TRANSMITTAL

BROOKFIELD FLOATING BRIDGE

BRIDGE REPLACEMENT PROJECT

FIBER REINFORCED POLYMER (FRP) PONTOON COMPONENT FABRICATION

SHEET: HALF TOP PLATE DIMENSIONS

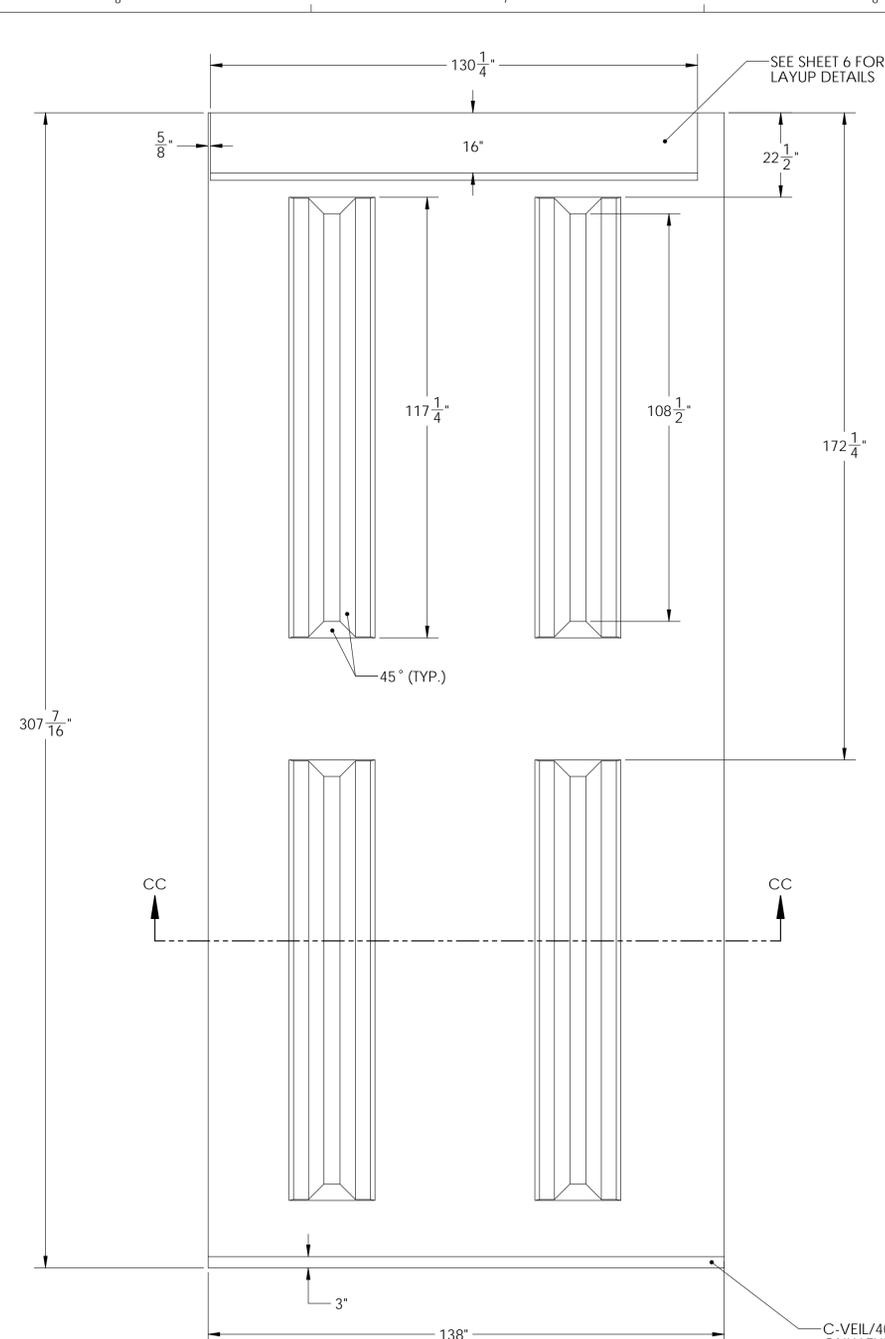
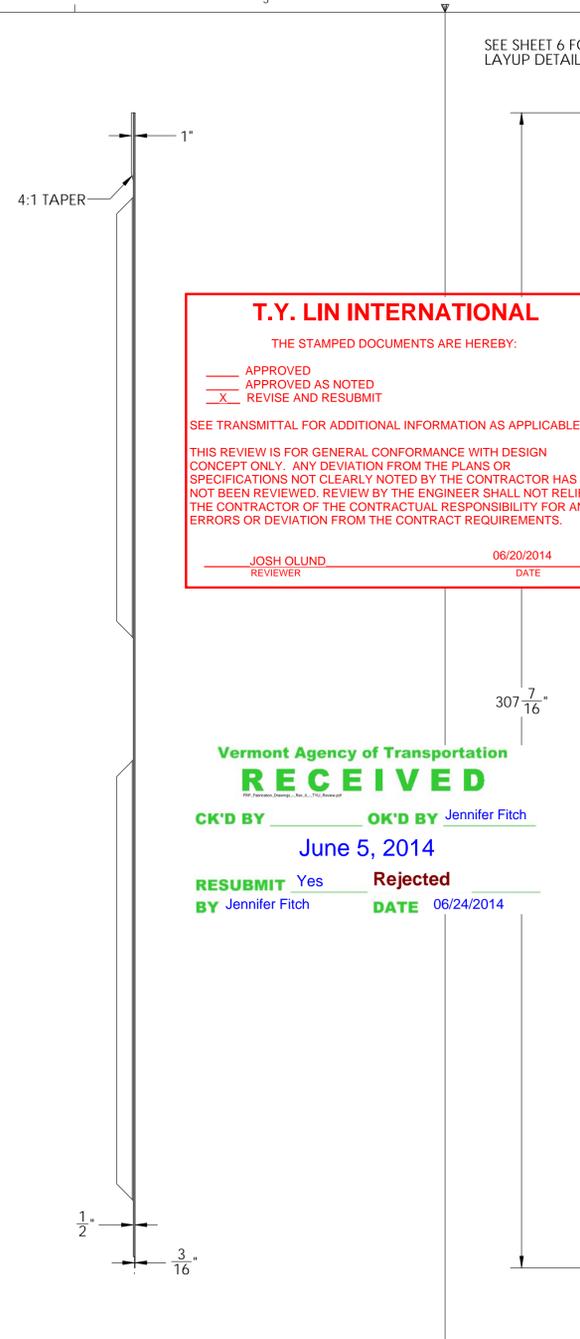
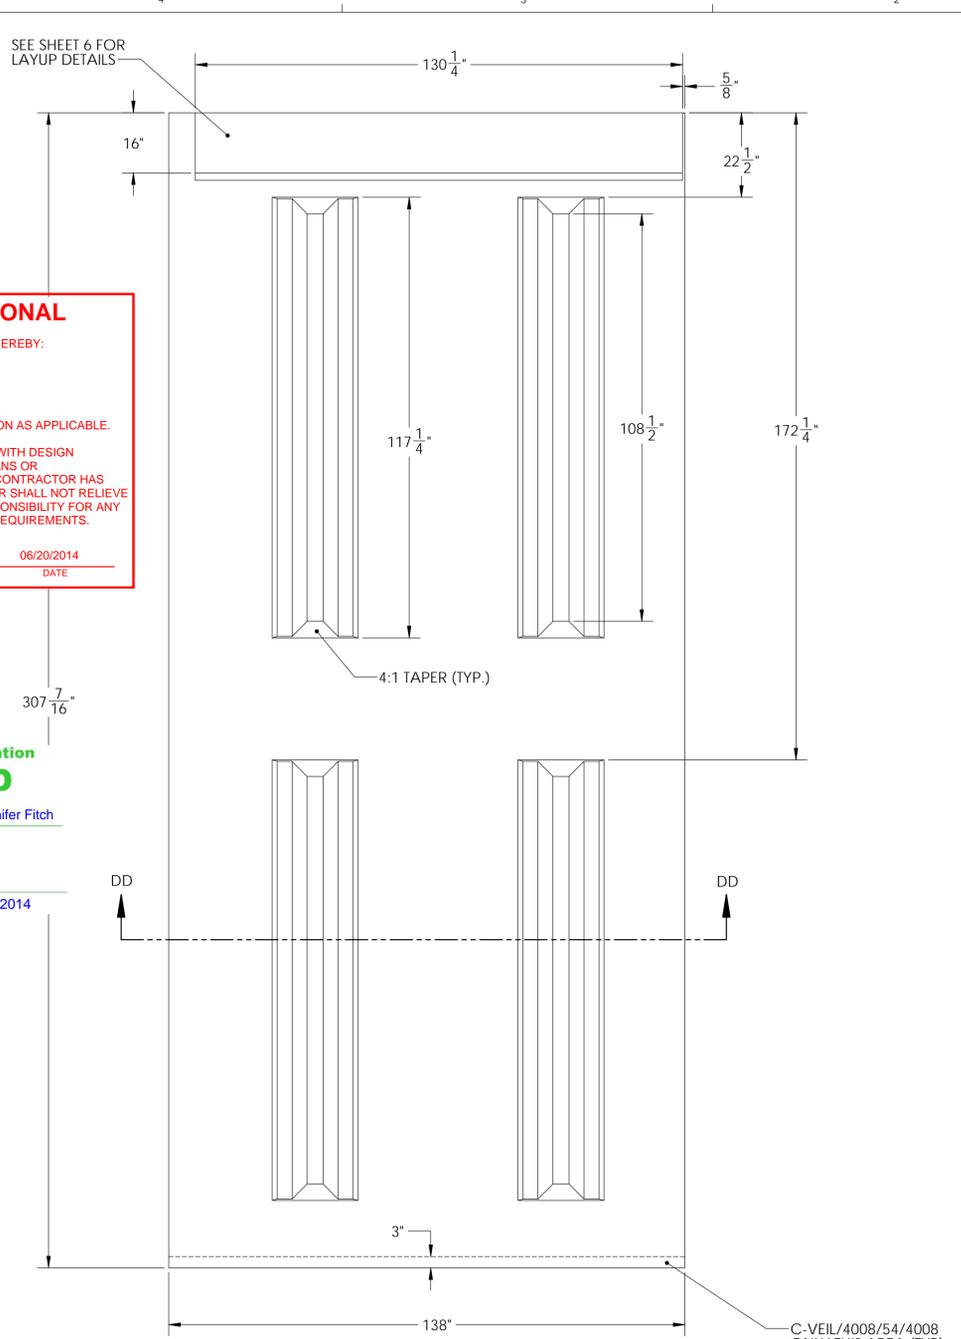
CLARIFY THE INTENT OF THIS STATEMENT. WHERE ARE DRILLING/PERFORATING OPERATIONS BEING CARRIED OUT AND FOR WHAT PURPOSE?

CUSTOMER
MILLER CONST. / VTRANS
SHEET
END HALF TOP PLATE DIMENSIONS

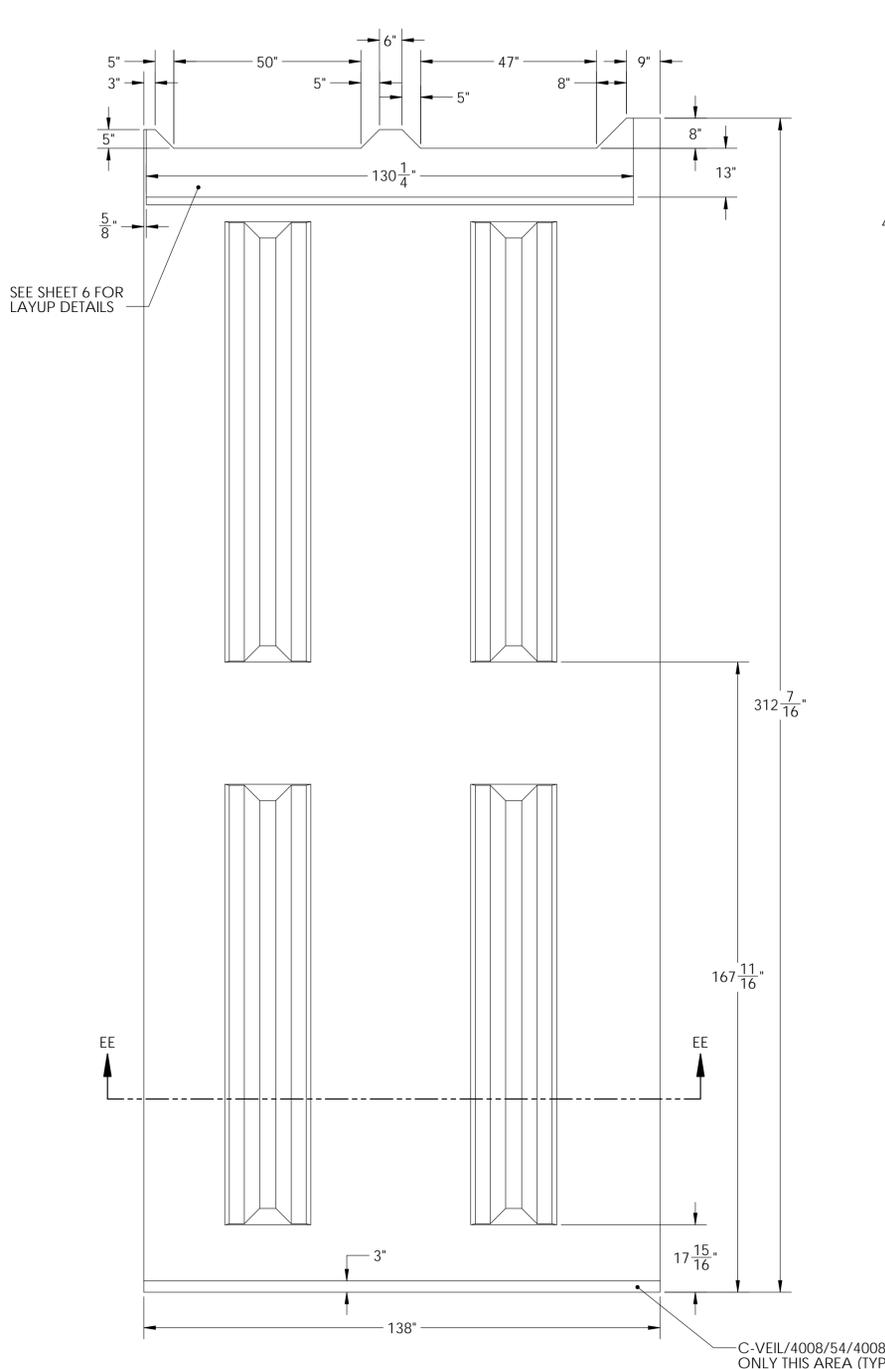
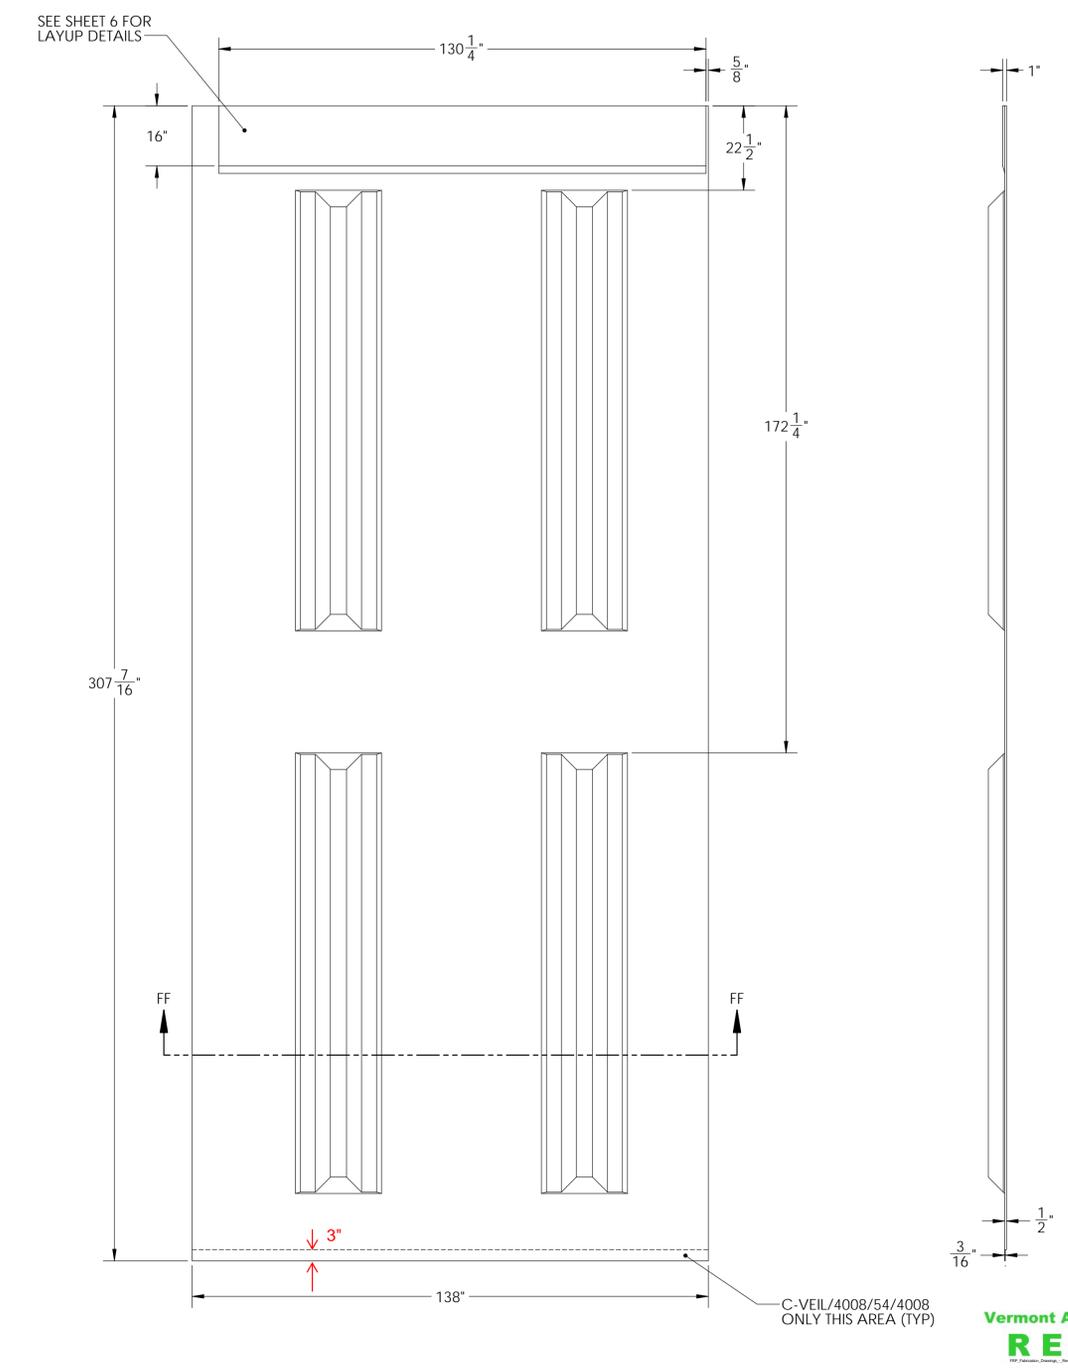
CLARIFY THE INTENT OF THIS STATEMENT. WHERE ARE DRILLING/PERFORATING OPERATIONS BEING CARRIED OUT AND FOR WHAT PURPOSE?
